SERVICE LETTER NO. 74-6

DATE: May 24, 1974

SUBJECT: BUSS BAR/BEARING COLLAR CLEARANCE

SERIALS AFFECTED: AA1B-0238 thru AA1B-0296, AA1B-0298 thru AA1B-0318,
AA1B-0320 thru AA1B-0337, AA1B-0339 thru AA1B-0343,
AA1B-0345 thru AA1B-0356, AA1B-0358 thru AA1B-0376,
AA1B-0380, AA1B-0382 thru AA1B-0384, AA1B-0386 thru
AA1B-0388, AA1B-0391 and AA1B-0395.

Figure 1. Buss Bar/Bearing Collar Clearance

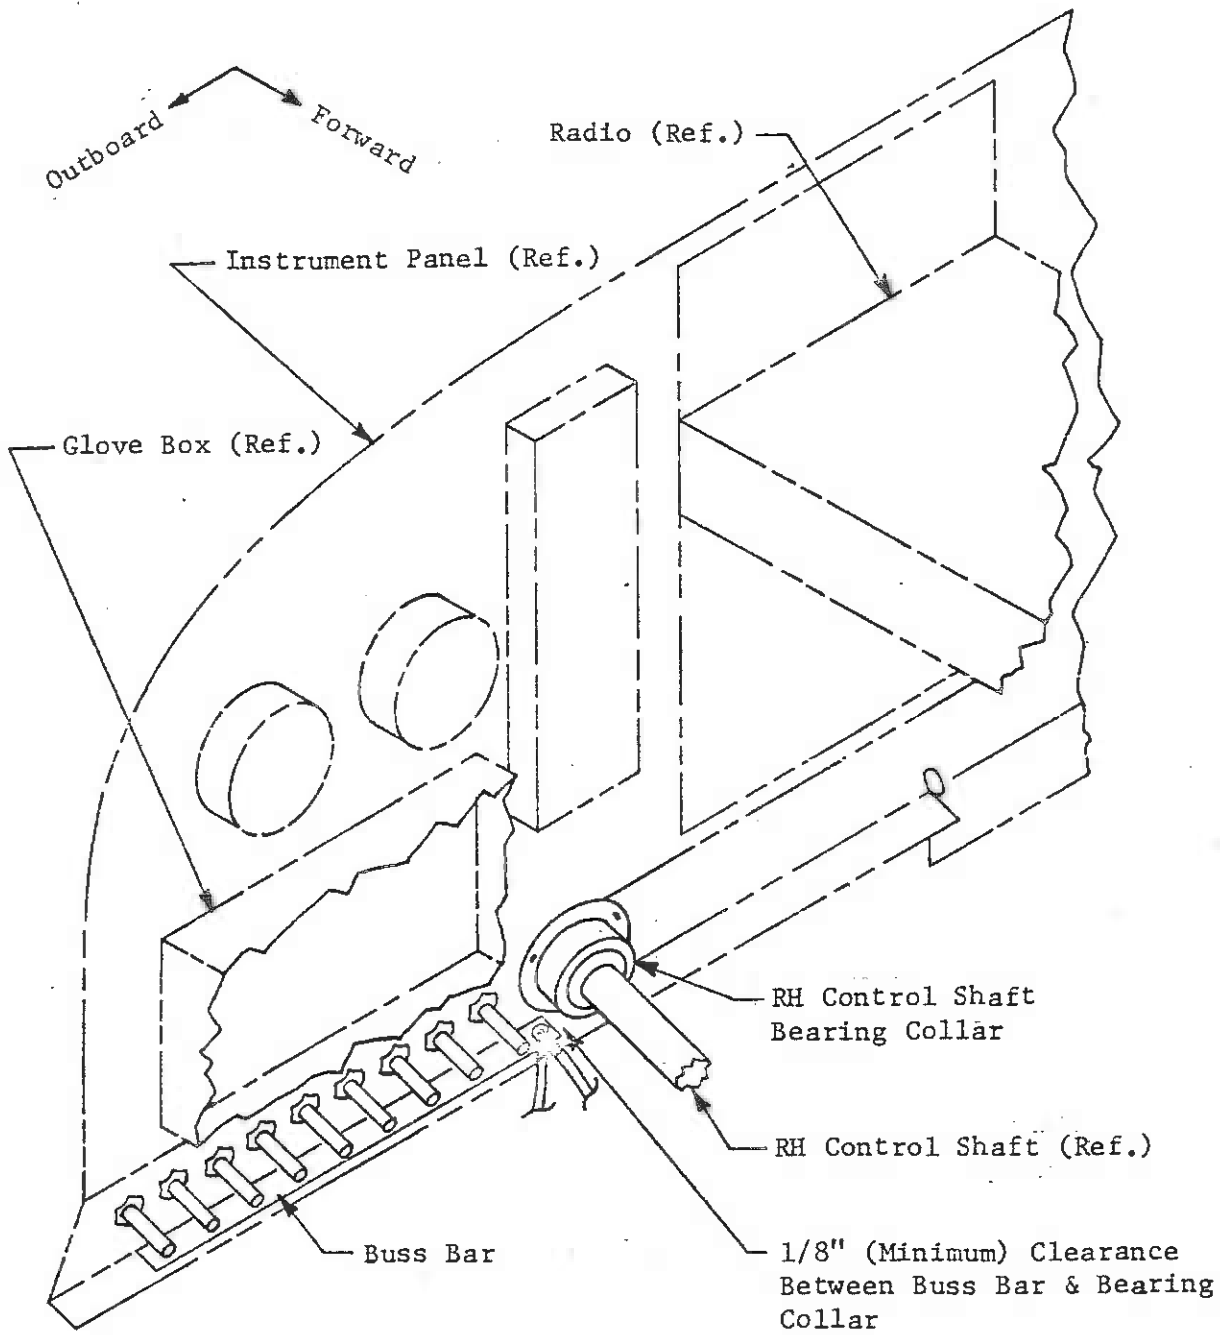
To preclude the possibility of inadvertent grounding of the electrical system, due to deflecting or bending of the buss bar, a recent production change has increased the clearance between the buss bar and the right hand control shaft bearing collar.

The minimum clearance between the buss bar and the right hand control shaft bearing collar is 1/8" (See Figure 1). This clearance may be checked as follows:

2. Remove the right hand control wheel shaft.
3. Remove the right hand vent airbox by taking out the two plug buttons on the under side of the box and using a long Phillips screwdriver, remove the screws attaching the airbox to the instrument panel.
4. Bend or trim the inboard aft corner of the buss bar to obtain 1/8" clearance between buss bar and the right hand control shaft bearing collar (See Figure 1).
